Duck River Parklands Draft Strategic Masterplan Submission

This submission has been prepared on behalf of CAMWEST, a Bicycle NSW affiliated Bicycle User Group with a focus on advocating for and encouraging cycling in the Blacktown, Parramatta, and Cumberland Local Government Areas of Western Sydney.

The lower portion of the study area, taken from 'Existing Local Connections Plan', page 37 of the Masterplan

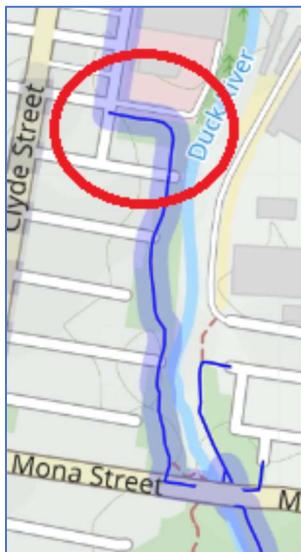
1. The most significant for us is the connection between where the shared path ends on the north side of Wellington Rd and alongside Chisolm Rd to Everley Rd (Green circled area on below image). We acknowledge that this current route is less than ideal, with the crossing of Wellington Rd and narrow paths, but it is an official path and does hold some utility.
2. The second is the path alongside Wellington Rd between Erie St and the current Duck River path (Orange Circled area). Another narrower than standard path, this one taking riders close to the roadway with no barriers in between. This path is used and useful.
3. The third is the path through New Glasgow Park, between Seventh and Factory Sts. (Red circled area).

Path ending at Seventh St in 'Existing Local Connections Plan'.

Actual path continues from Seventh St through New Glasgow Park to Factory St.

Route from Princes St West at the top of the map to cross over the railway line near Sefton Station

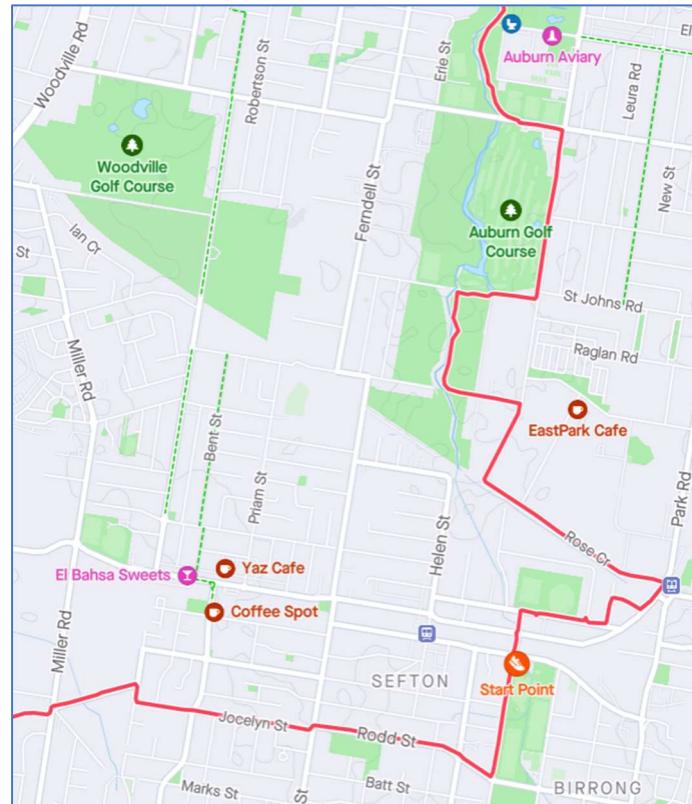
To get from the end of the path at Princes Rd West to the southern side of the pipeline is quite a roundabout route, going through the somewhat intimidating industrial area around Rose Crescent, and for some people riding illegally on footpaths through Regents Park to cross over the pipeline.

Rather than this circuitous route, we would love to see the bridge between Boundary Rd and the existing shared path (Princes Rd West) where the current causeway exists (Red line on map - Project ID 19 in section 5.7 of the Masterplan) fast tracked. From our perspective, this is the highest priority linkage in the Masterplan. As well as connections to the south, this would also provide an important East-West connection.

The long wished-for bridge over the Duck River at Boundary Rd (in red) with a possible connection to the new Hector St bridge (in blue).

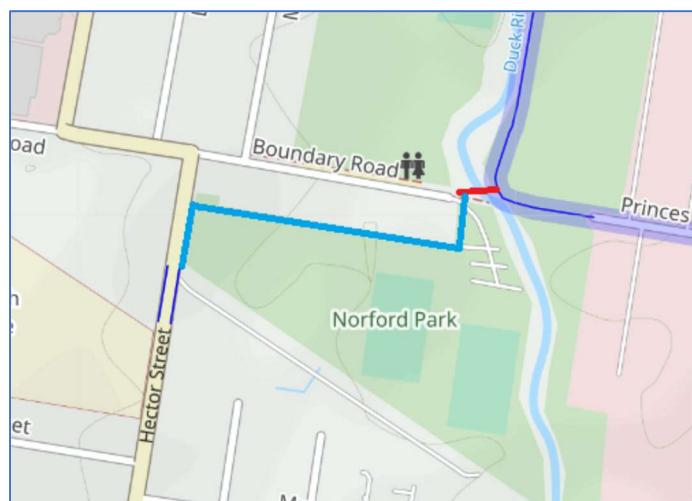
The blue route through Norford Park is shown on the Masterplan, but it is unclear to us whether it is a shared path or not. This would be a great connection with the shared path alongside the new Hector St pipeline crossing bridge.

Part of 'The Wilds' precinct, north of Mona St

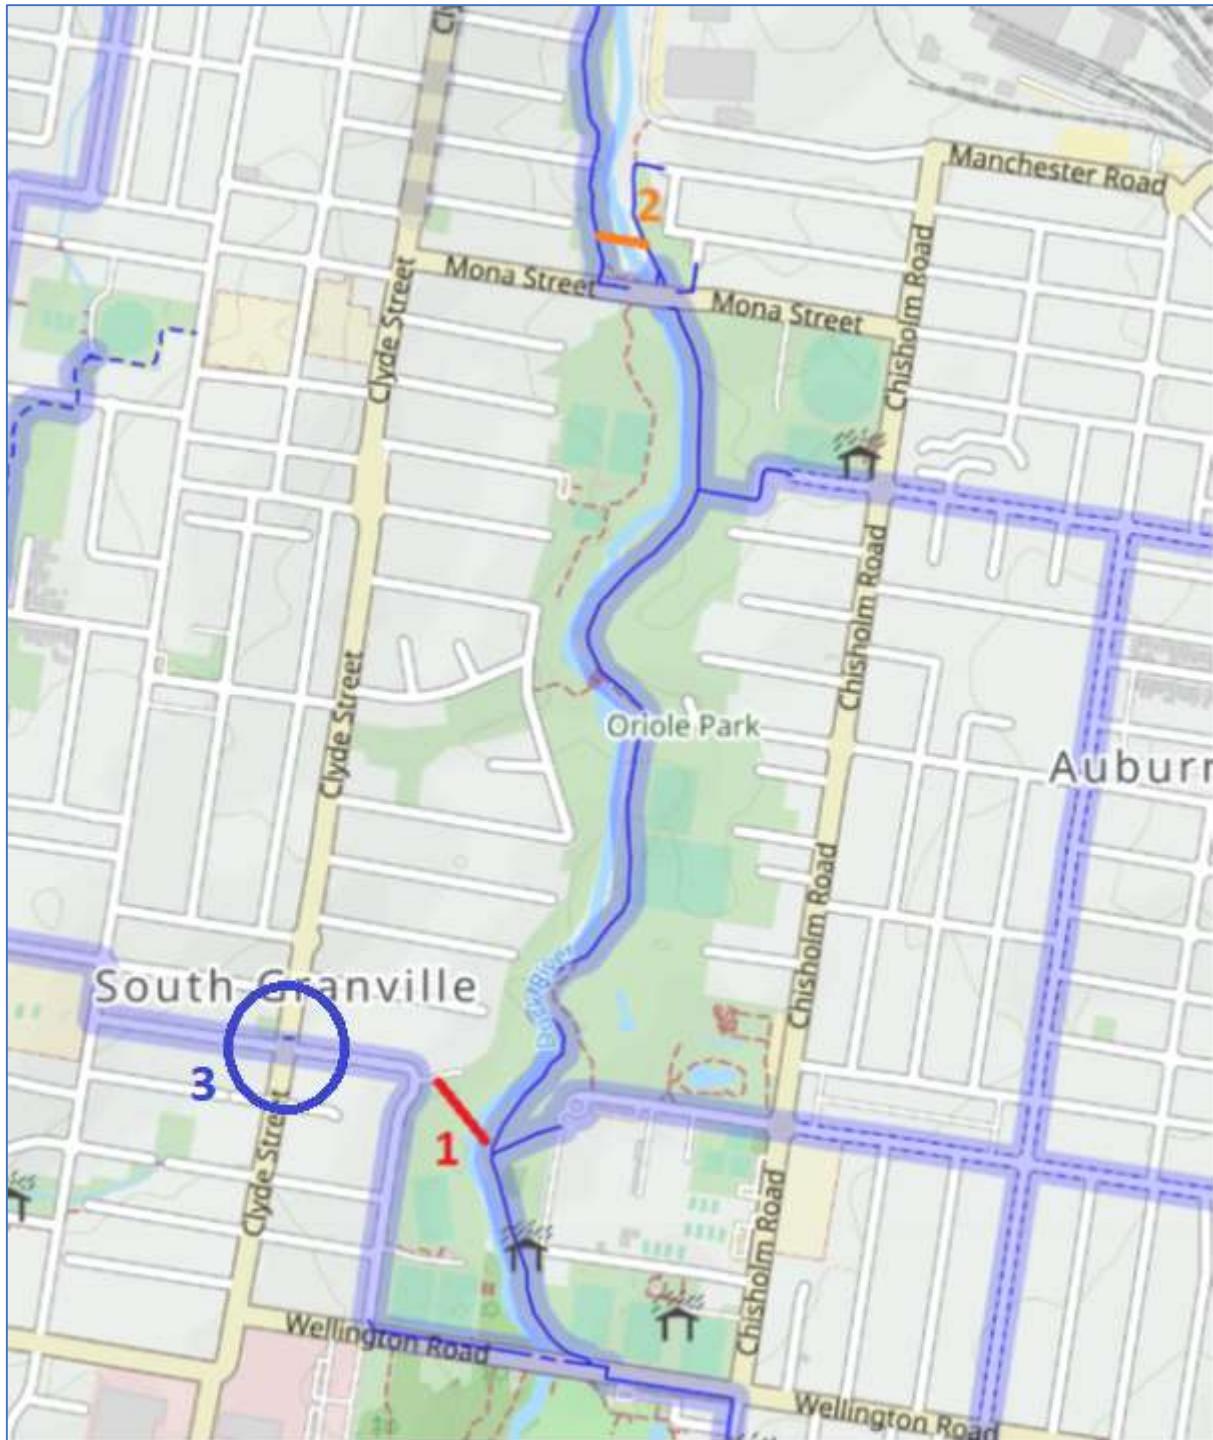
1. It's good to see a proposed route from the current termination of the shared path at Sheffield St (Bangor Park) through to Manchester Rd – see the red circled area on map to the right. There is a currently a short unofficial but widely used 'walking track' across land owned by Sydney Water which connects the two. It's interesting that there's a separate proposed path that appears to cross the Sydney Water land, while the proposed cycling route circumvents it through what appears to currently be private property.
If able to be built, this would provide both an alternative to Factory St and form the basis of a useful loop around 'The Wilds' precinct for local residents.

Map showing two current crossings of Wellington Rd, suggested traffic light crossing, and proposed path (from the Masterplan) along the western edge of the Wategora precinct.

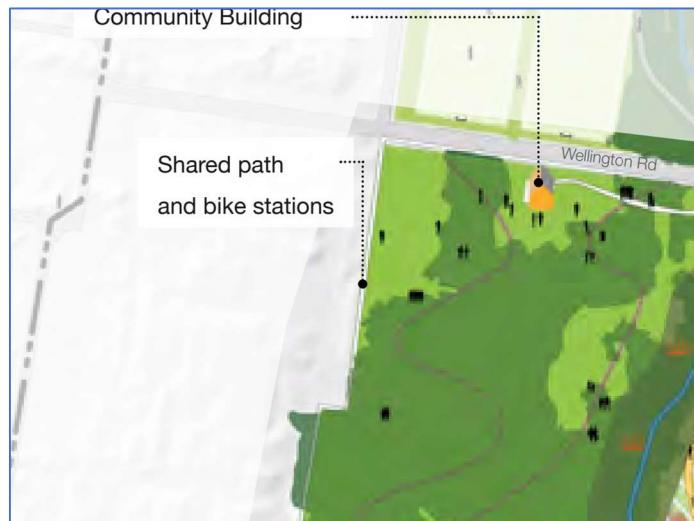
- If not cost and engineering prohibitive, we believe it would be safer in the short to medium term if the current shared-path crossing of Wellington Rd could be moved to the signalised crossing at Chisom Rd. We're aware that this would require a reasonably major reconfiguring of the lights at this intersection and so may not be practicable.

If able to be implemented, this would also assist pedestrians walking along the western side of Chisom Rd. At present to cross Wellington Rd legally pedestrians need to do three crosses at the traffic signals or walk down and back to the shared path crossing.

Sediment across parts of the path in several locations.

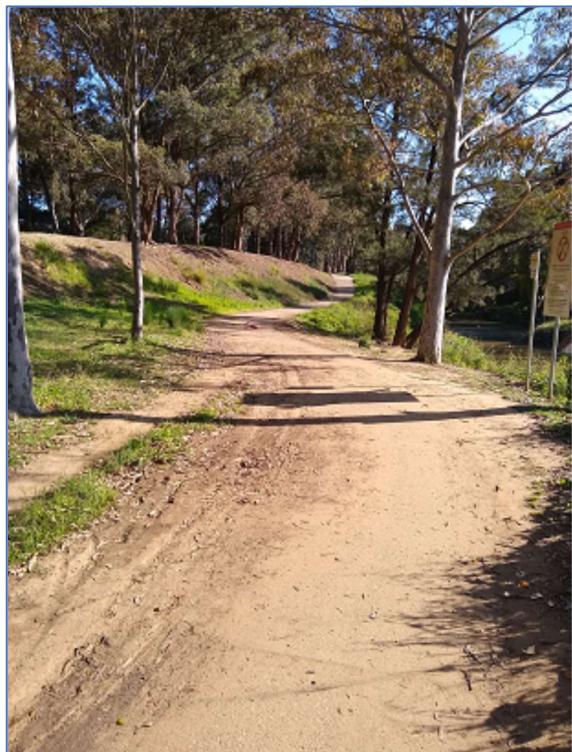
Sediment and water on pathway: This can make the pathway slippery and dangerous for riders.

CAMWEST are not huge fans of 'Cross' intersections

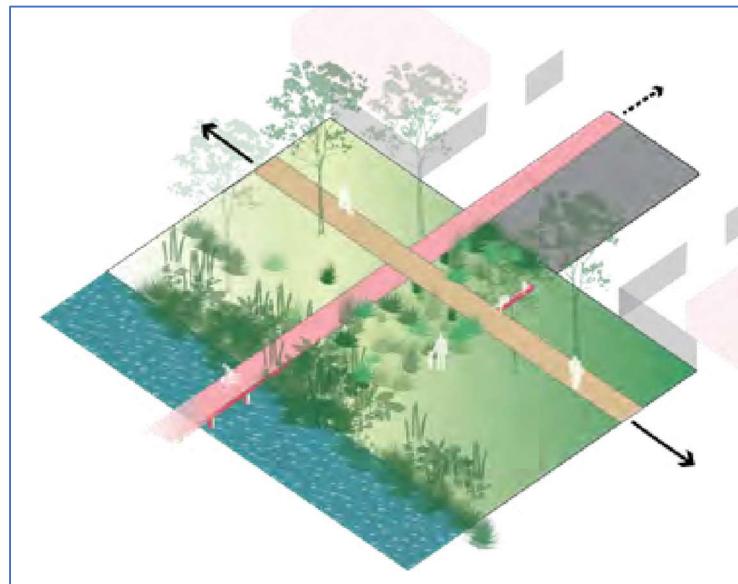
- From a safety perspective, CAMWEST aren't terribly keen on 'cross' intersections. We believe it may be safer to have offset 'T' intersections. If the offset model is adopted, the challenge is to stop people creating diagonal shortcuts.
